Planning Commission Staff Report

Project Type: Amended Lighting Plan

Description: **Drury Plaza Hotel (Hyatt Place):** An Amended Lighting Plan for a 4.85 acre tract of land zoned "PC" Planned Commercial District located adjacent to Chesterfield Mall at the intersection of Clarkson Road and U.S. Highway 40/Interstate 64.

AMENDED LIGHTING PLAN

Light fixture approved in 2012

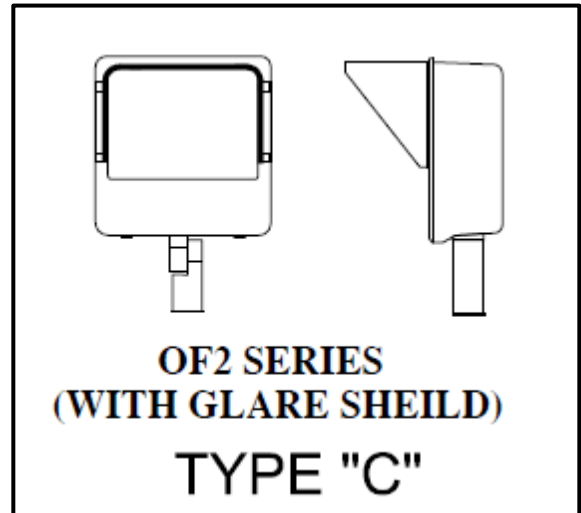
A Lighting Plan was approved with the Site Development Section Plan in January of 2012. The Lighting Plan showed seven single head pole mounted light fixtures to be installed in the parking area. However, during a routine construction inspection, Staff noted that five of the fixtures included a second directional light fixture intended to up light the three primary building elevations, as shown in the 3D/Isometric Lighting Plan included in the Applicant's submittal. The City of Chesterfield Lighting Ordinance states that "parking lot lighting shall be full shielded flat-lens enclosed luminaires."

As the installed light fixtures do not meet these criteria, the Applicant is seeking an exemption as permitted by the City of Chesterfield Lighting Ordinance which states:

“The Planning Commission may approve decorative light fixtures as an alternative to shielded fixtures when it can be proven that there will be no off-site glare light trespass in excess of .5 foot candle and the proposed fixtures will improve the appearance of the site.”

PHOTOMETRIC PLAN
HYATT PLACE #21
333 Chesterfield Center East, Chesterfield, MO. 63017.

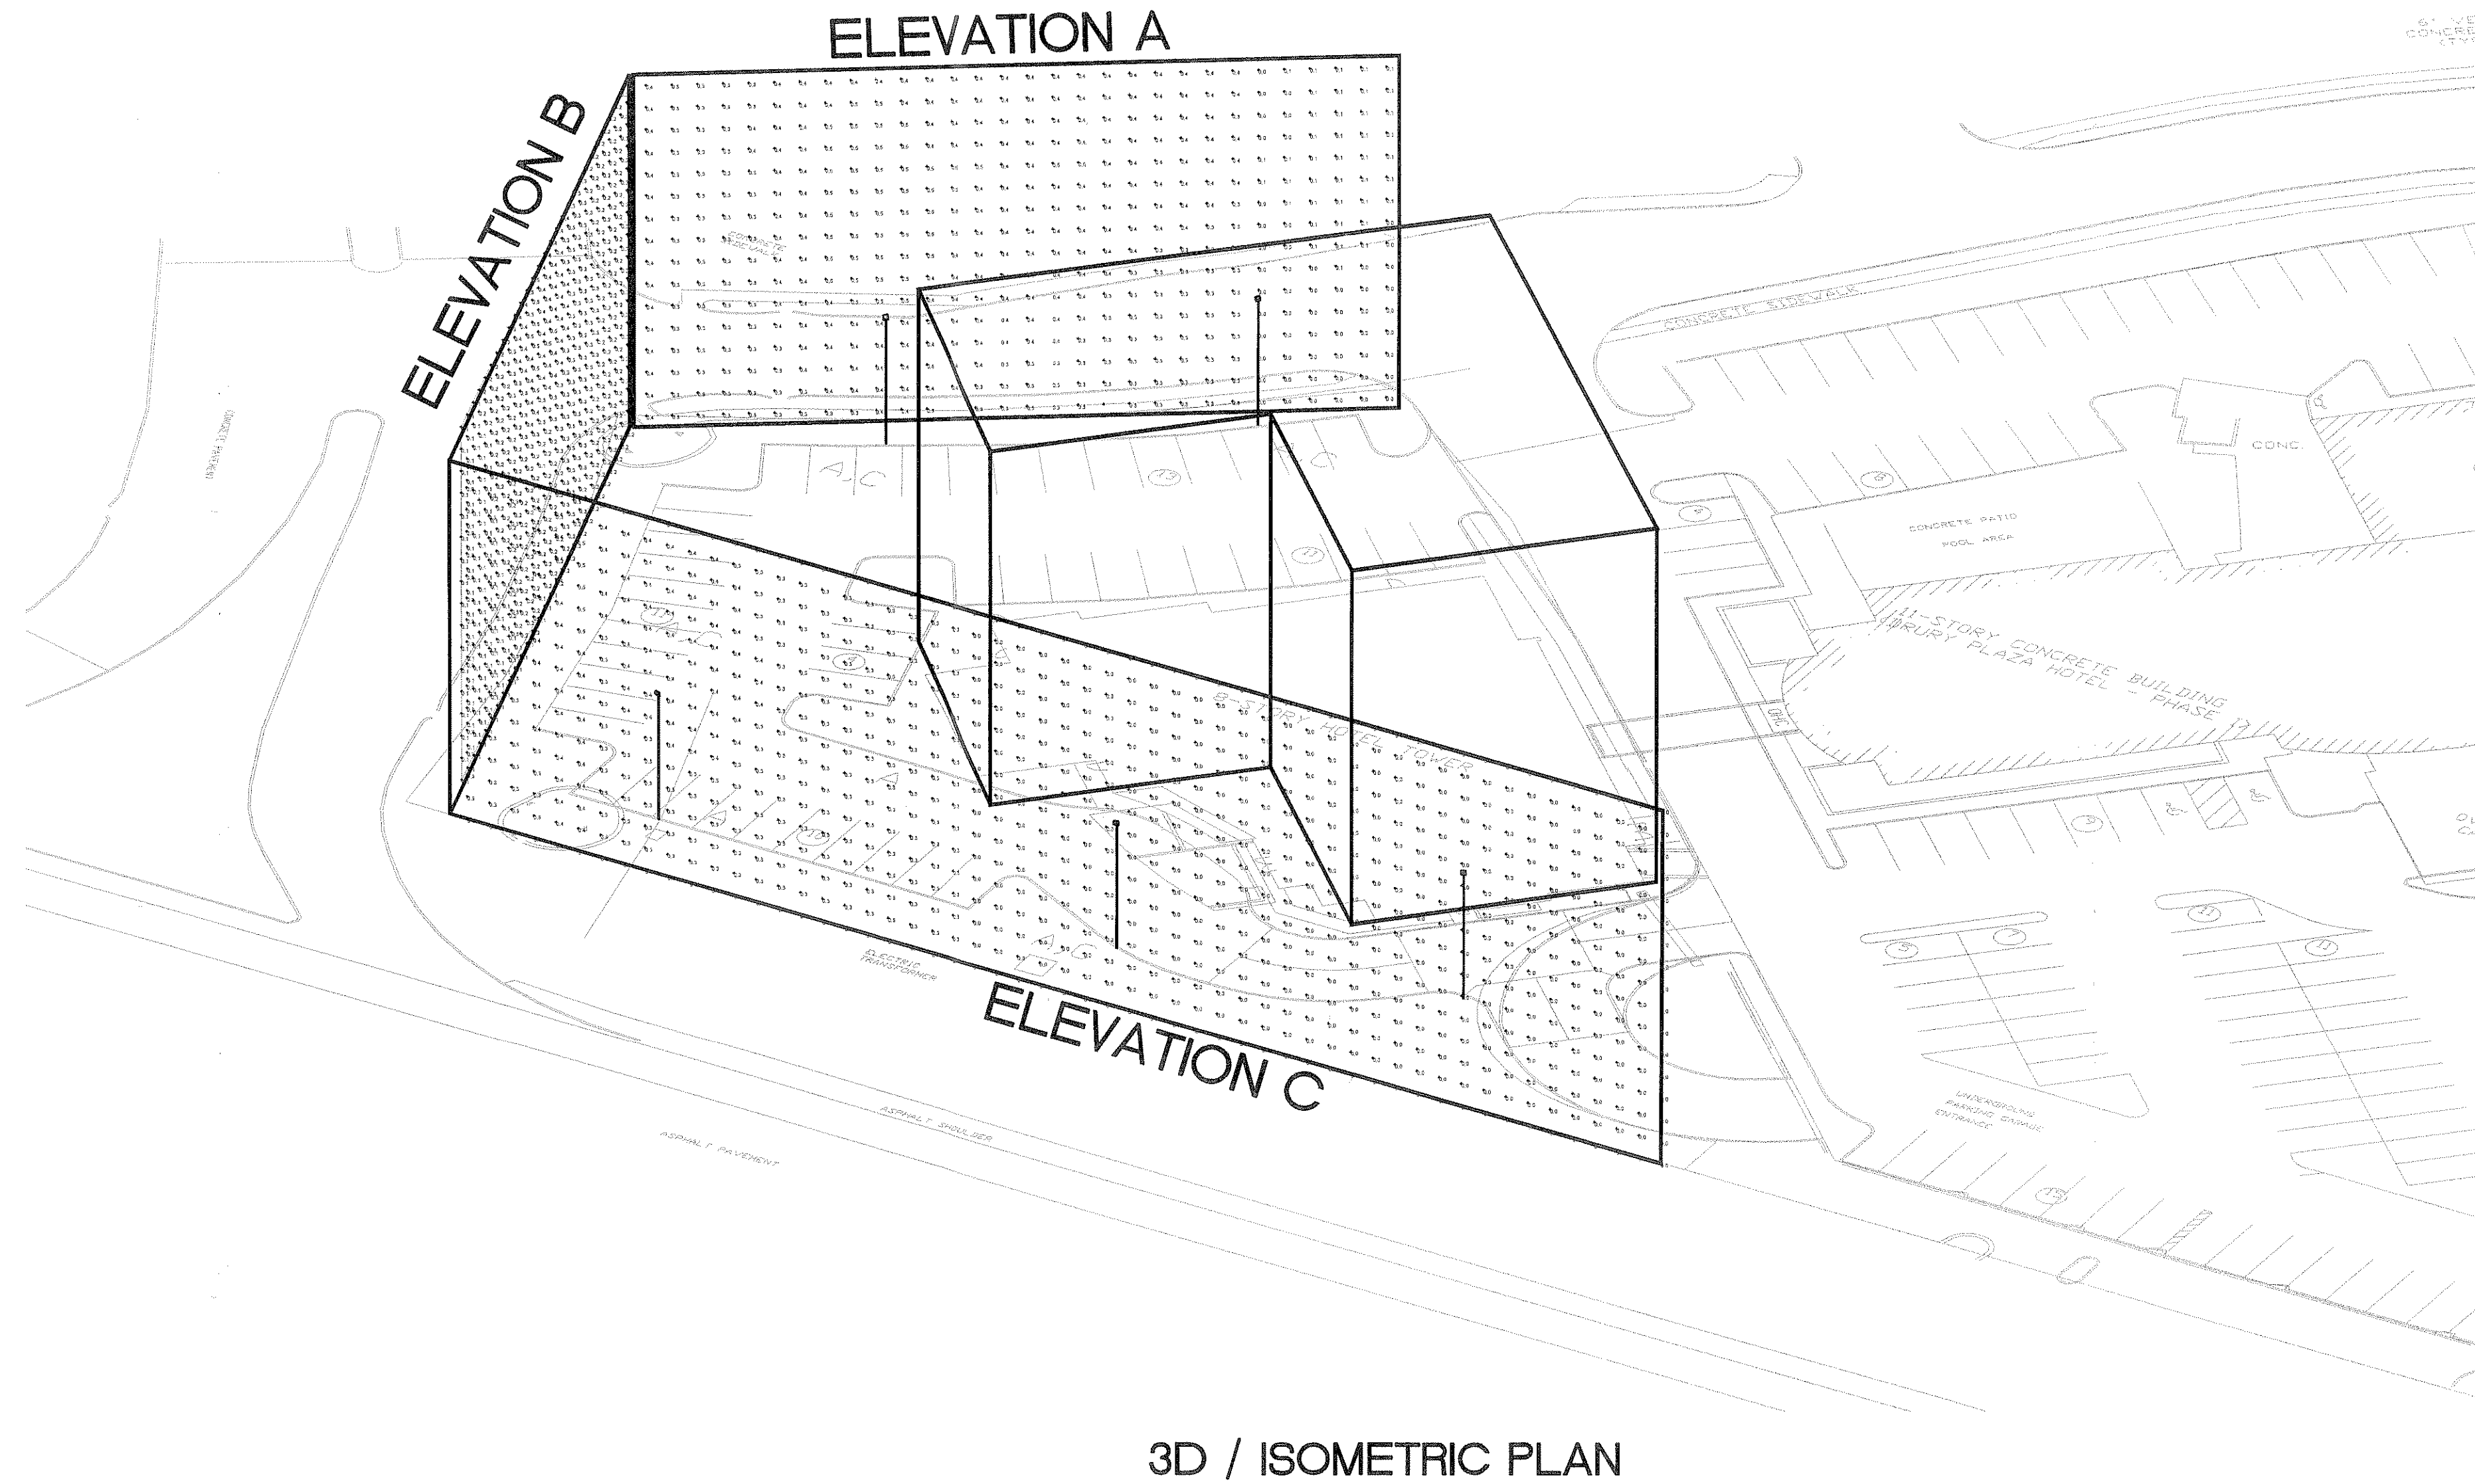
This letter is in regards to the Amended Lighting Plan for Hyatt Place Chesterfield submitted by Drury Development Corporation (DDC). Our request to amend the lighting plan pertains specifically to the addition of fixtures which provide accent uplighting on the building's façades. The additional fixtures are pole mounted on the approved parking lighting and are tilted upward to wash the building exterior.

The attachments to this letter include a photo and a cut sheet of the fixture in question as well as an amended Lighting Plan showing these additional fixtures. DDC has also submitted an additional axonometric lighting study that shows the light trespass at the property line three dimensionally to address any City concerns that these fixtures would create light trespass beyond the building façade or upward towards the night sky. Furthermore, due to the mounting height and directionality of these fixtures there should be no concern of glare at grade. Finally, the parking lighting does have some areas exceed the 8.0 footcandle maximum. These isolated areas do go as high as 9.5 footcandles, however this is consistent with the previously approved Lighting Plan and the adjacent lots in the area.

3D/ISOMETRIC PLAN

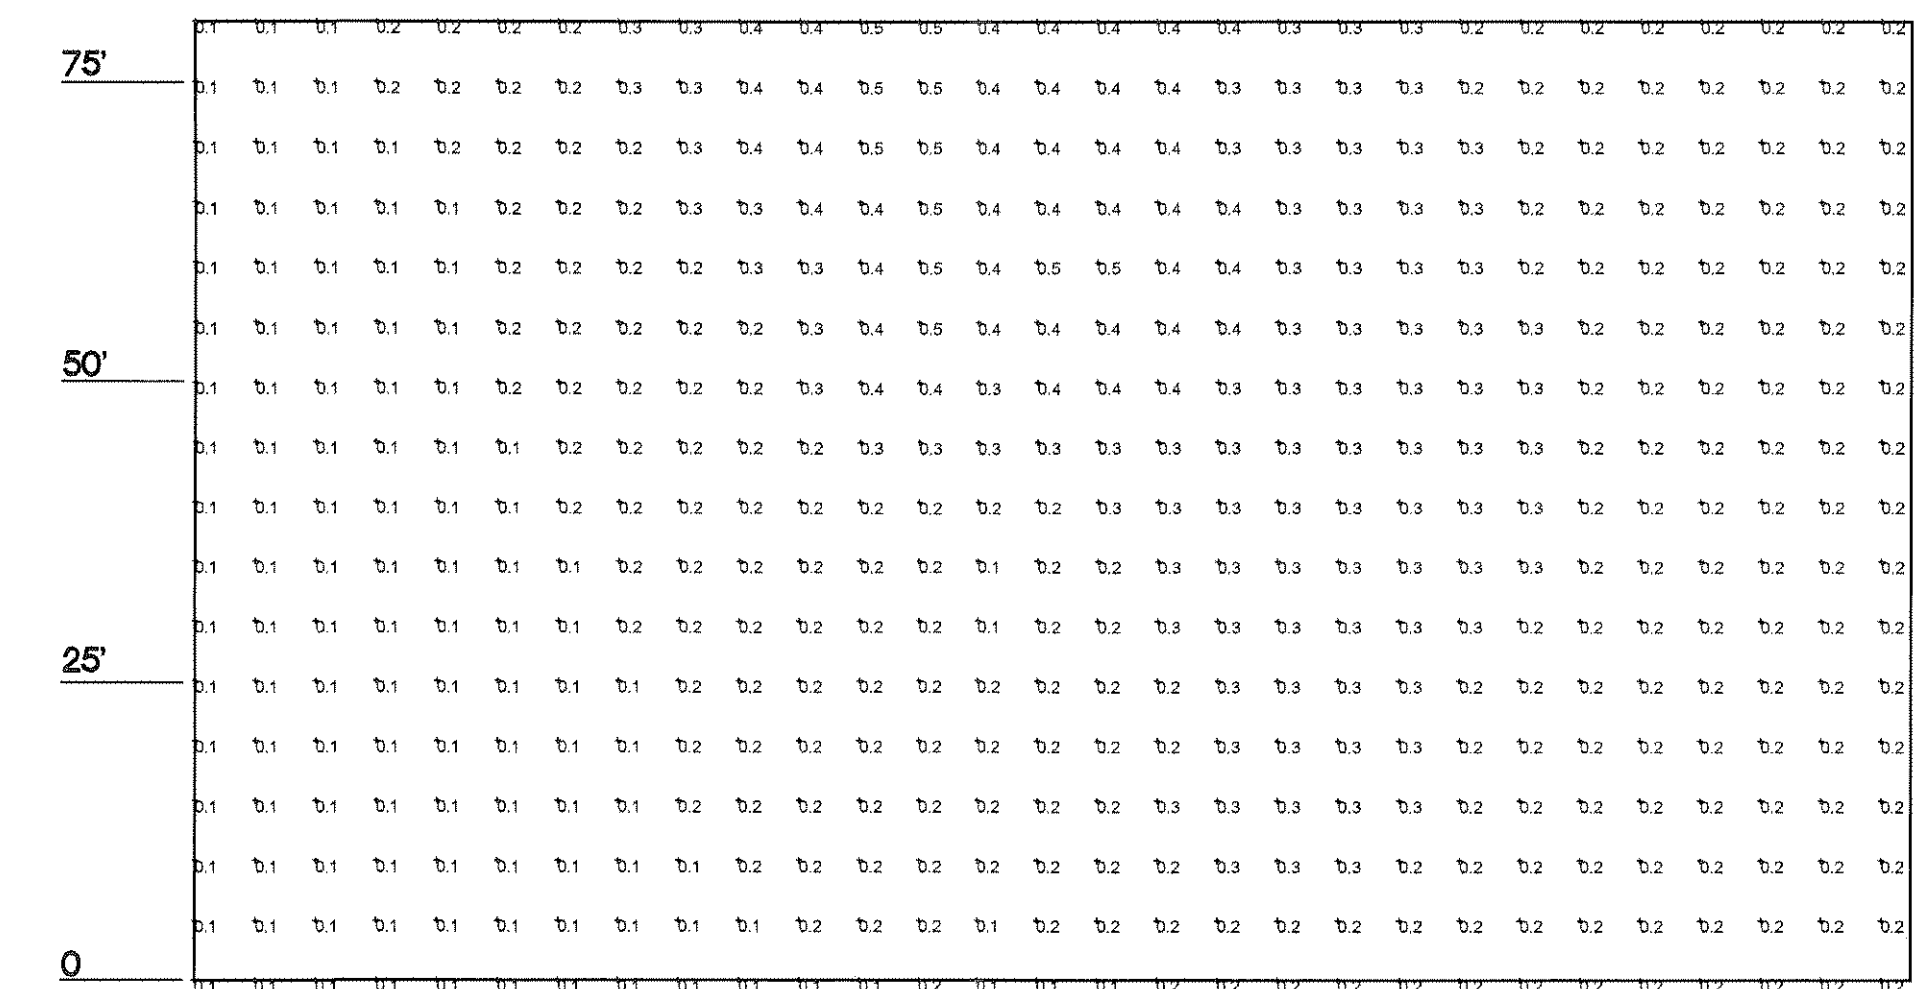
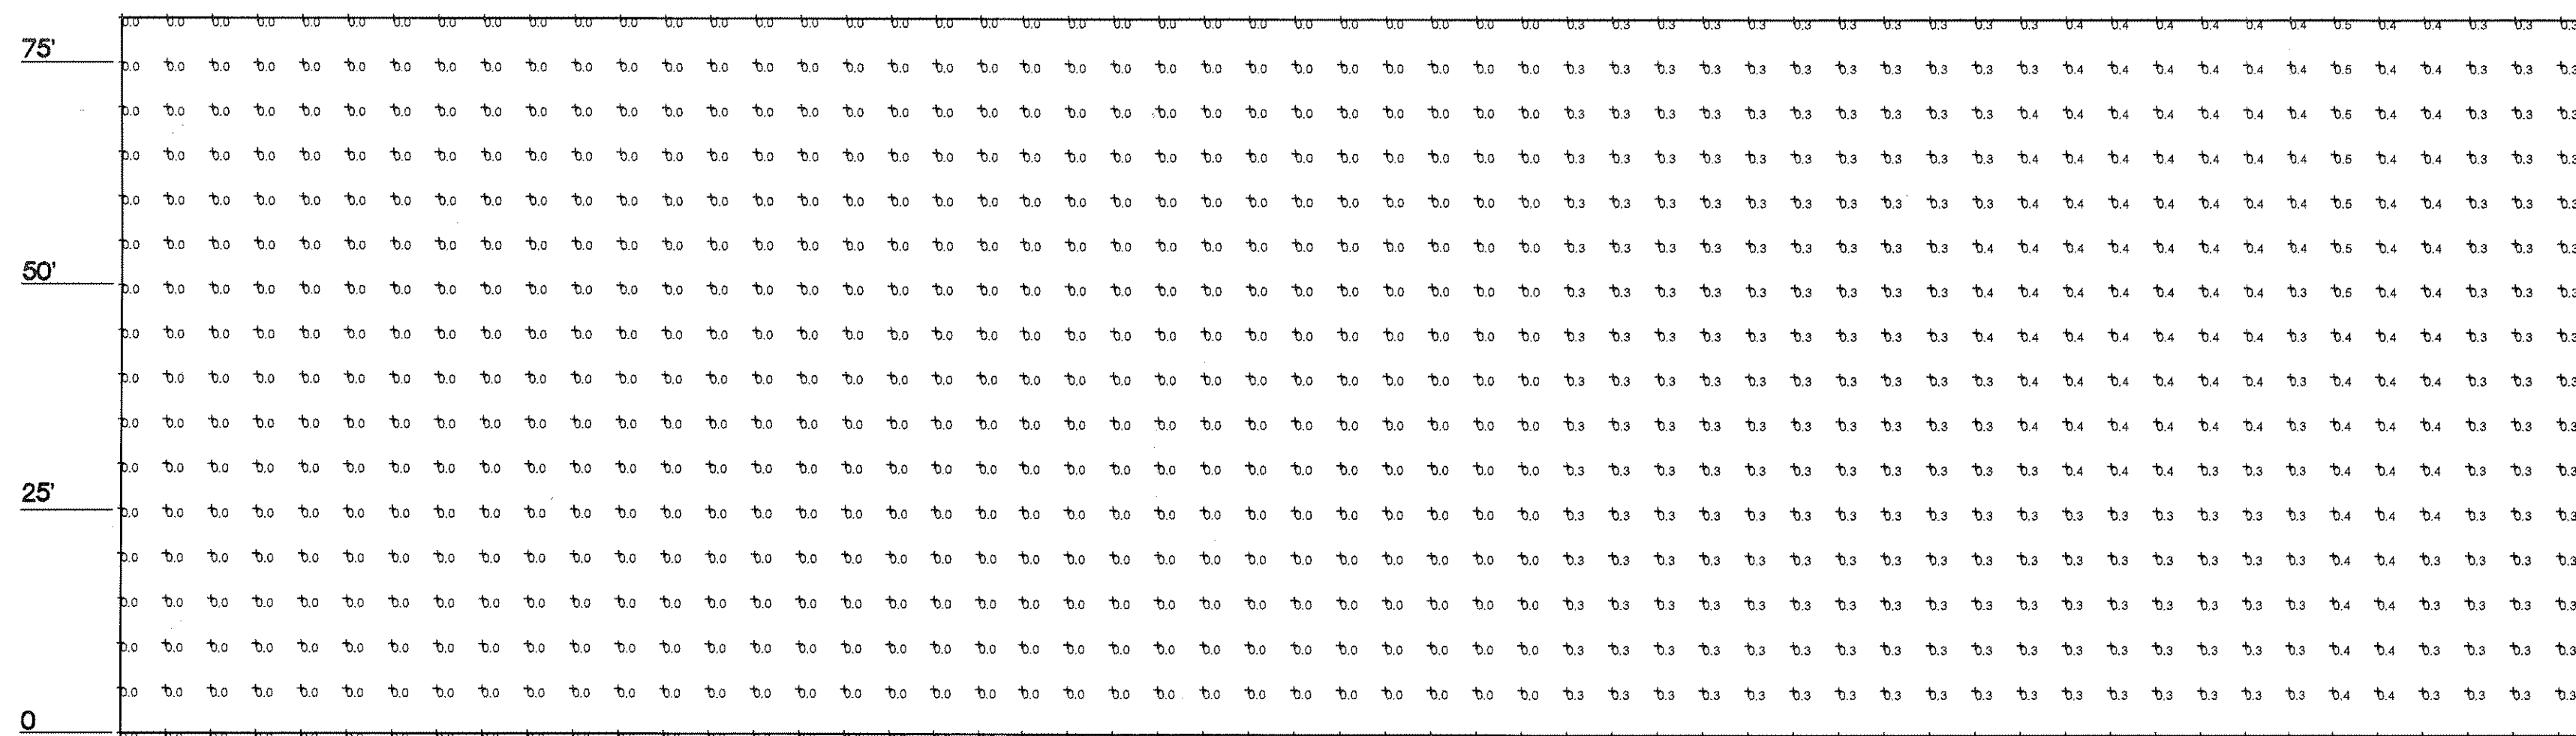
It is important to note that there is no change in light levels from the Lighting Plan previously approved by City Council in 2012. As stated in the Applicant’s narrative, the intent of the lighting design is to provide uniformity and continuity between the adjacent Drury Plaza Hotel and the newly constructed Hyatt Place Hotel. The directional up lights provide illumination of the façade of the building without excessive sky glow or light spill over, as demonstrated by the 3D/Isometric Lighting Plan.
